March 13, 2026

**RE: Comments on Draft Bakersfield Field Office Oil and Gas Leasing and Development Supplemental Environmental Impact Statement, Docket No. DOI-BLM-CA-C060-2025-0053-EIS**

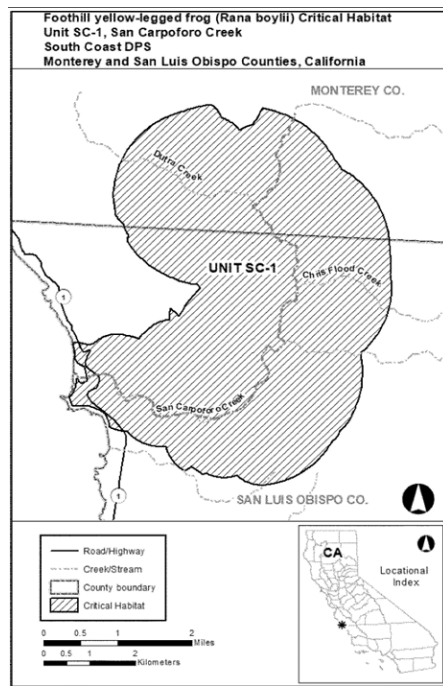
Further, proposed critical habitat Unit SC-1 (see map below)<sup>381</sup> appears to intersect with federal lands open for leasing under the RMP in northwest San Luis Obispo County.

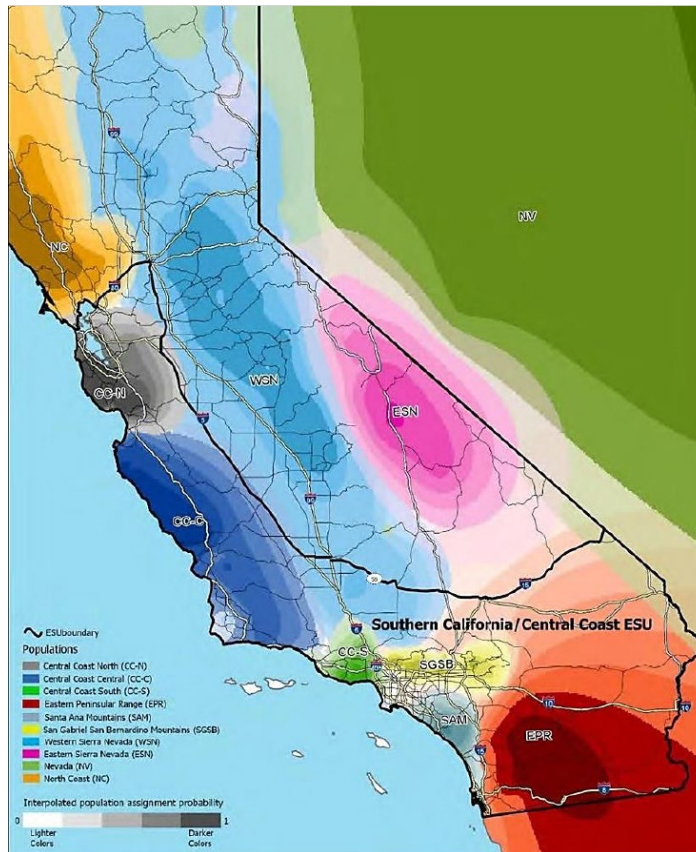
There is a wealth of recent scientific studies that address threats to mountain lions. These studies illuminate, for example, the dire conditions of the DPS’s genetic health and viability, the myriad threats they face, and the importance of the lease area for their long-term survival.<sup>440</sup> The research cited in CDFW’s Status Review and this Comment represent the best available science

Figure 2: Active oil and gas development in the Temblor legless lizard range and overlap with lizard detection sites.

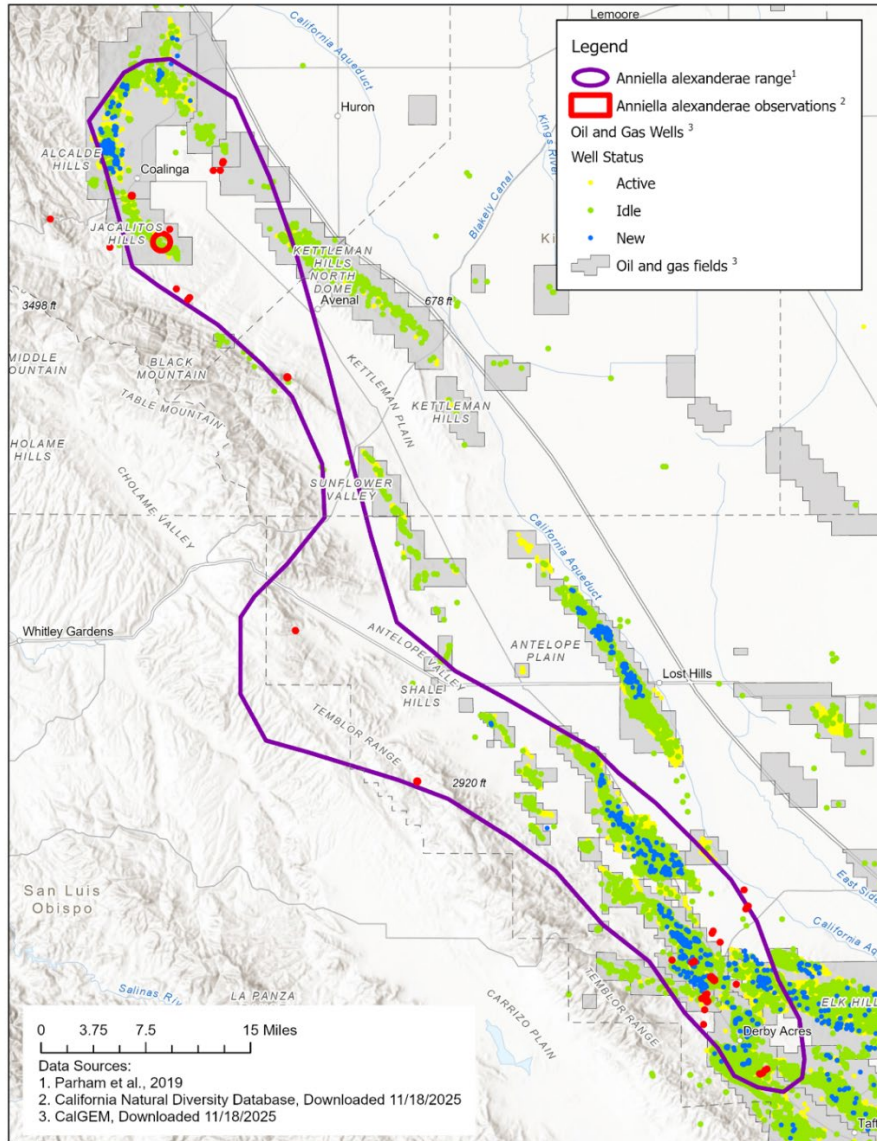
Rose et al. (2024) researchers also found that “a few negative surveys are not sufficient to conclude that this species is absent from a site.”<sup>464</sup> At many sites, TLL were not observed until the researchers had conducted three or more surveys. At three of 12 sites where lizards were detected over the 2-year survey period, lizards were observed during surveys in one year but not in the other year. The study further concluded that their “results also show that surveys over multiple years might be needed to document the presence of Temblor legless lizards, particularly during droughts when conditions at the surface are unsuitable.”<sup>465</sup>
